Job 72426067REP1	Truss B2	Truss Type Truss	Qty 6	Ply 1	PARKS BLDG/J-LYNN ELEV. A RF Job Reference (optional)
---------------------	-------------	---------------------	----------	----------	--

Repair for a 6" wide by 1" deep semi-circular notch in the top edge of the bottom chord where indicated.

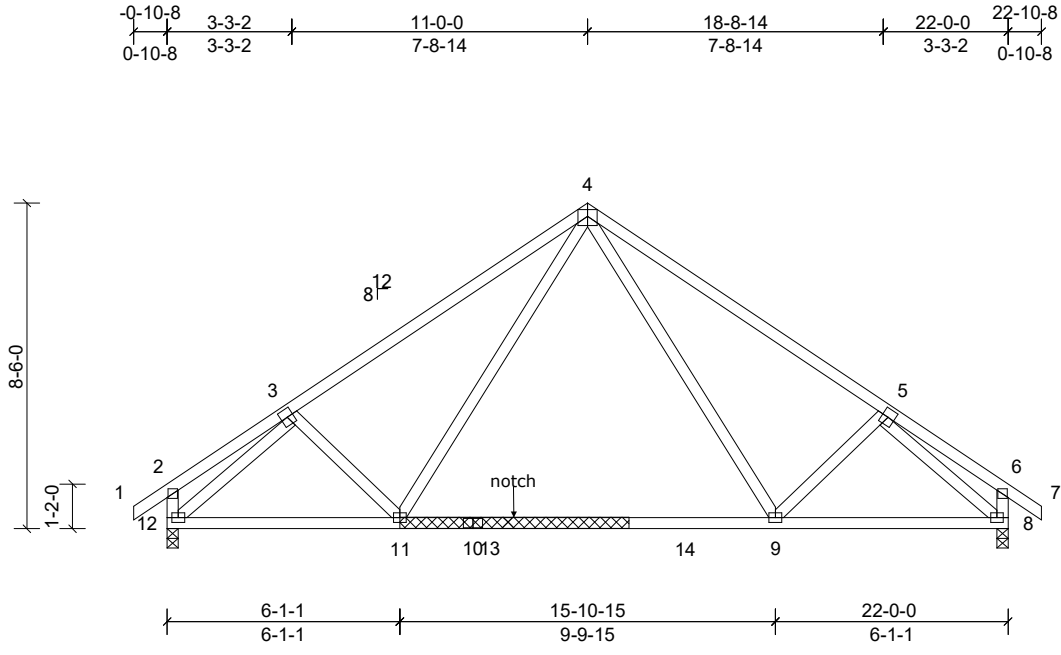
- This repair has been prepared based on information and use conditions supplied by client. Designer has made a good faith effort to outline damage and repair conditions as reported by client. When actual field conditions do not approximate those indicated on this drawing, client shall immediately inform the engineer and refrain from applying the repair.

Attach 2x4 x 6' SP or SPF No.2 scab to each face of truss centered on notch with 2 rows of 10d (.131" x 3") nails spaced 4" oc DO NOT notch scabs.
